## Santa Ana Regional Water Quality Control Board

**COMMENTS ON WORK PLAN ADDENDUM FOR SUPPLEMENTAL  
GROUNDWATER WELL INSTALLATION – PURSUANT TO CLEANUP AND  
ABATEMENT ORDER NO. R8-2013-0048 FOR THE FORMER IDEAL UNIFORM  
RENTAL SERVICE SITE; 13811 A BETTER WAY, GARDEN GROVE, CALIFORNIA  
(GLOBAL ID: SL0605946450; PCA# 2080071)**

Enclosure 1 – Proposed Intermediate and Deep WBZ Groundwater Sampling Locations, Geosyntec, April 3, 2020)

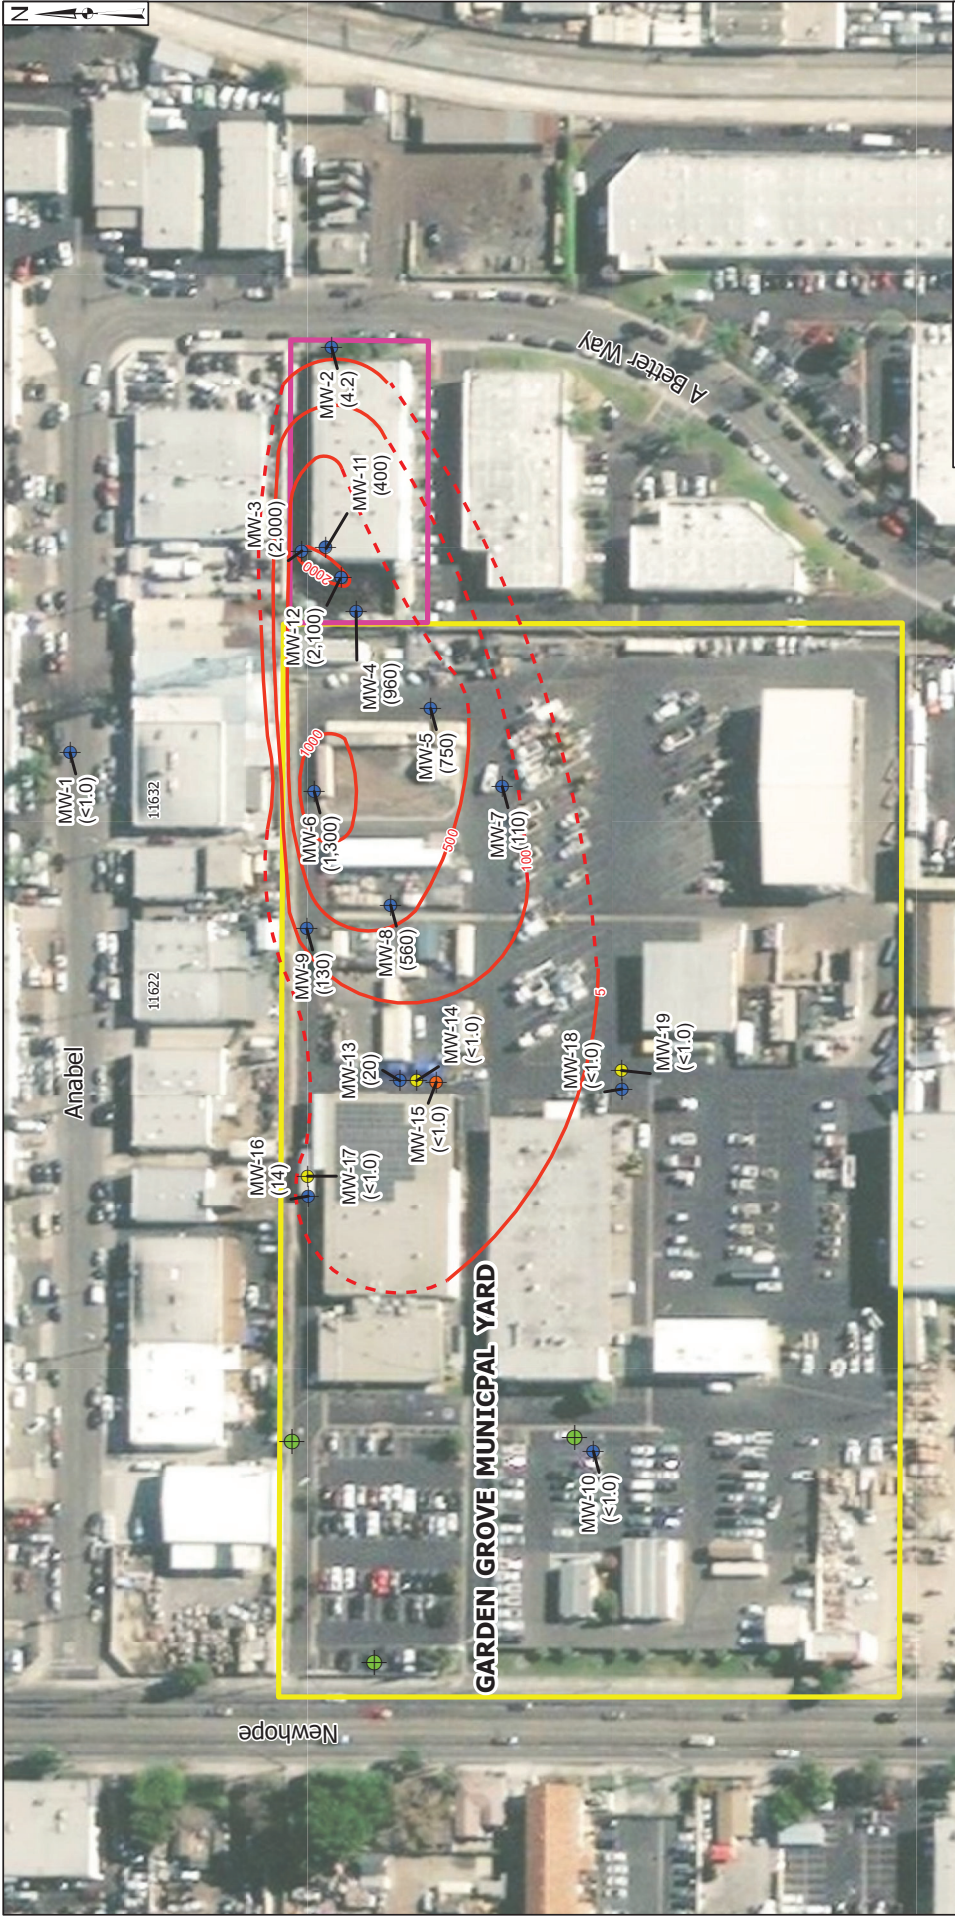
- Obtain necessary permits from Orange County Health Care Agency and coordinate access with the City of Garden Grove to the Municipal Yard property located at 13802 Newhope Street in Garden Grove (City Yard).
- Advance six borings using a direct push Cone Penetration Testing (CPT) rig; two borings at each sampling location presented in Enclosure 1, to approximate

As previously proposed, groundwater monitoring wells will be installed in the Shallow WBZ at the western and northwestern locations of the City Yard (Enclosure 1). You have proposed to collect groundwater samples using direct push technology prior to determining the locations and screened intervals of future off-Site groundwater monitoring wells to be installed in the intermediate and deep WBZs in the western half of the City Yard property. We provided our concurrence with the general locations and field methods for the installation of the proposed wells in our letters dated February 20, 2020, and February 28, 2020. The final construction of the groundwater monitoring wells for each WBZ should be based on the lithologic logs from the CPT fieldwork and the lithology observed in the field during the well installation activities.

1. Soil lithology data must be collected using the CPT rig prior to collecting the grab groundwater samples to aid in determining the sample collection depths.
